PREVOST

SAFETY RECALL

SR25-13

DATE:	June 2025	SECTION: 16 SUSPENSION
SUBJECT:	RETORQUE IFS LOWER CONTROL ARM BOLTS

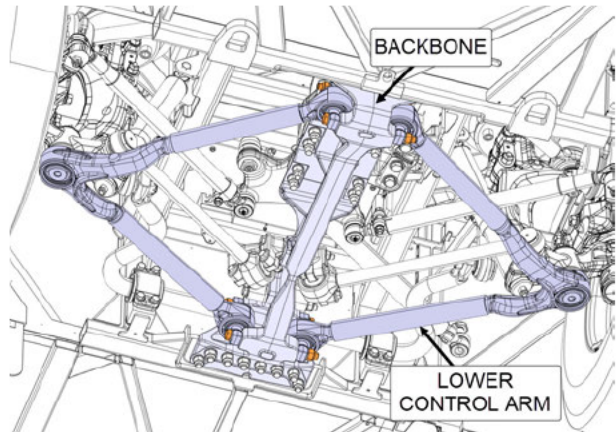
2. Locate the four bolts securing the lower control arms of the front suspension to the backbone.

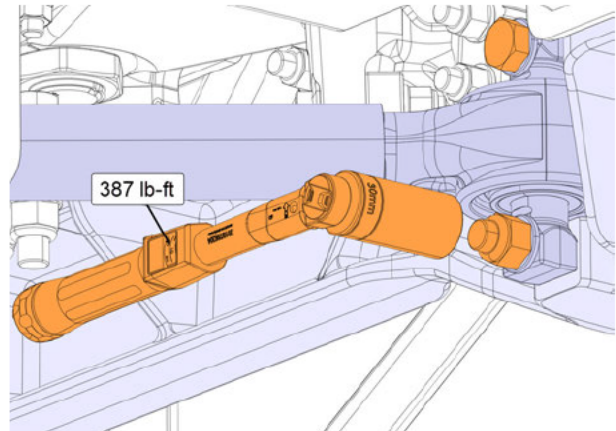
3. Torque each bolt to **387 lb-ft**.
4. Apply red torque seal mark.
